Project	IEEE 802.16 Broadband Wireless Access Working Group < http://ieee802.org/16 >	
Title	Space-Time Codes for 3 Transmit antennas for the OFDMA PHY	
Date Submitted	2004-07-07	
Source(s)	<p>Erik Lindskog, V. Shashidhar, B. Sundar Rajan, Djordje Tajkovic, David Garrett, K. Giridhar, Bob Lorenz, Babu Mandava, A. Paulraj, Taiwen Tang, Tareq Al-Naffouri, Erik Stauffer, Trevor Pearman, Kamlesh Rath, Aditya Agrawal, Mai Vu, Brett Schein Beceem Communications, Inc. Freedom Circle, Suite 101 Santa Clara, CA 95054</p> <p>Wonil Roh, JeongTae Oh, Chan-Byoung Chae, Kyunbyoung Ko, Hongsil Jeong, Sung-Ryul Yun, Samsung Electronics Co., Ltd.</p>	<p>Voice: +1-408-387-5021 Fax: +1-408-496-0040 elindskog@beceem.com</p> <p>wonil.roh@samsung.com Voice: +82-31-279-3868</p>
Re:	802.16e/D4	
Abstract	Space-time codes for 3 transmit antennas with full diversity.	
Purpose	To propose 3 transmit antenna space-time codes for 802.16e/D4.

Space-Time Codes for 3 Transmit antennas for the OFDMA PHY

[Figure ccc - Pilot allocation for 3-antenna BS for the optional FUSC and the optional AMC zones](#)

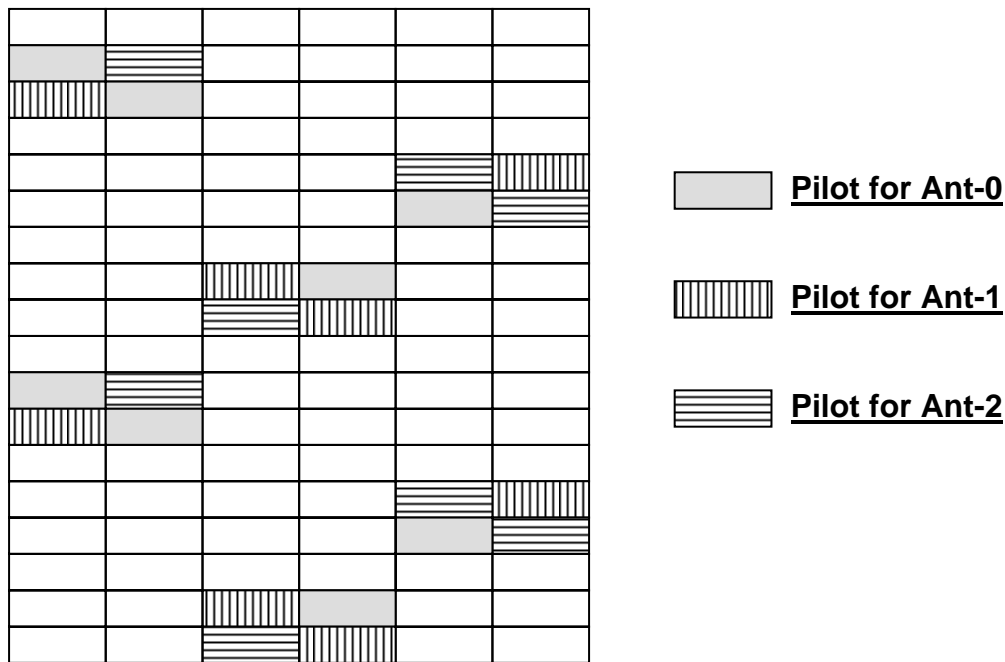
[For 3-antenna BS, pilot allocation pattern shall first be changed as in the 2-antenna BS case, and then the neighboring two subcarriers shall be further allocated as pilots. This is shown in Figure ccc.](#)
